Monthly Specification Update

Intel® Workstation Board S5520SC

Intel Order Number E68106-023

August, 2011

28. Wrong Fan Fault LED may glow if "other chassis" is selected when flashing FRUSDR21

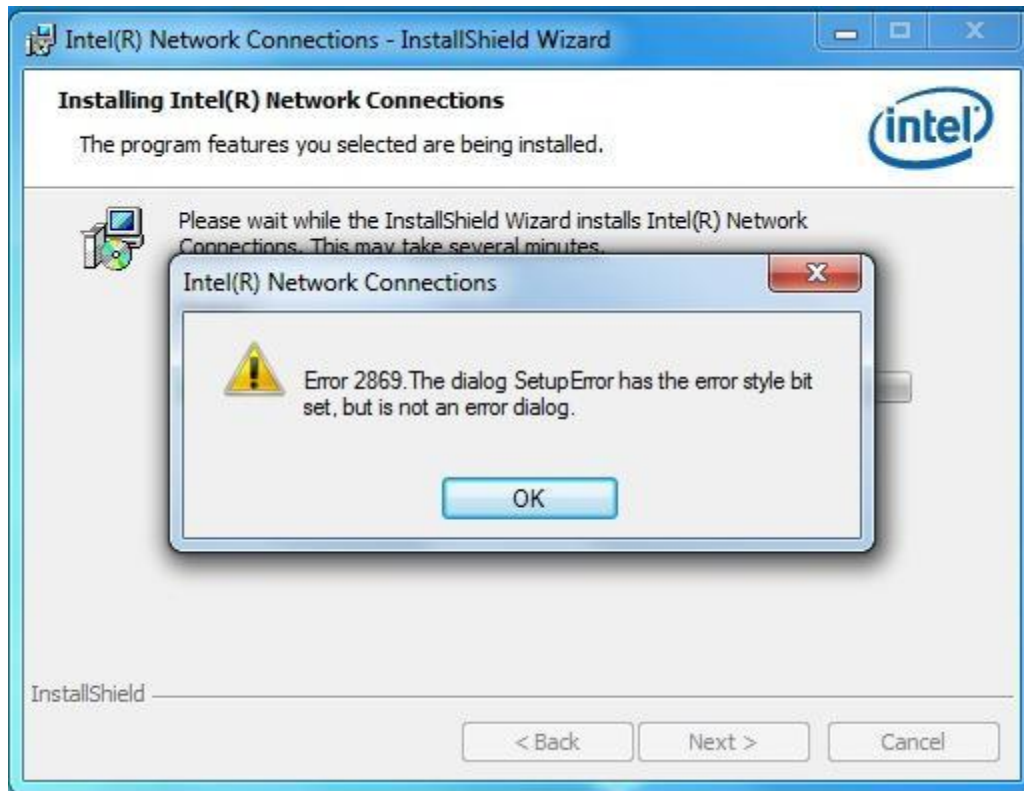
Problem When users update FRUSDR21 and select "other chassis" in the update process, users may see CPU FAN2 Fault LED glow when the upgrade process finishes. This issue occurs only when one CPU is installed in the motherboard.

Implication The unexpected CPU FAN2 Fault LED glowing event is due to a FRUSDR issue, however, there will be no functional impact to the system.

Status This issue is fixed by FRUSDR25.

30. NIC driver 15.1.1 may not be installed properly in Microsoft Windows Vista* or Microsoft Windows 7*

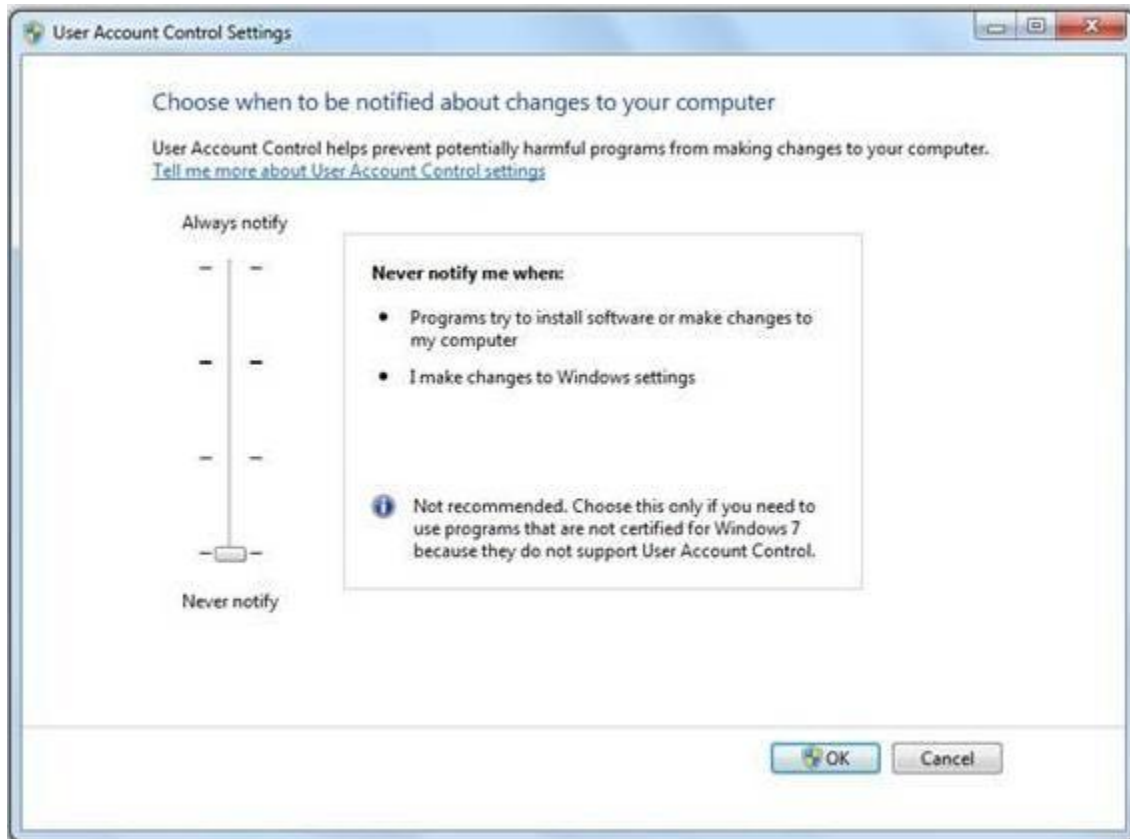
Problem	Users may find onboard NIC (Network Interface Card) driver version 15.1.1 may not get installed properly in Microsoft Windows Vista* or Microsoft Windows 7* when UAC (User Access Control) is set as "Default". Problem may occur during the installation process of the NIC driver, scramble display and unexpected message may display as following:
---------	---

- Implication** This is a permissions issue with Microsoft Windows Vista* and later operating systems. Permissions don't get elevated installing with PROSETDX.MSI, which is the file the batch file in the root directory points to. DXsetup gets the permissions elevated on Microsoft Windows Vista* and later operating systems, but they don't get elevated if you launch the MSI without DXsetup.
- Status** This issue will be fixed by future NIC driver release.
- Workaround** The following workaround can be used to navigate around the issue.
1. Users can browse to the \apps\prosetdx\ - 2. Users can also refer to below picture to set Windows UAC (User Account Control) to "Never notify", re-install the driver after a system reboot.
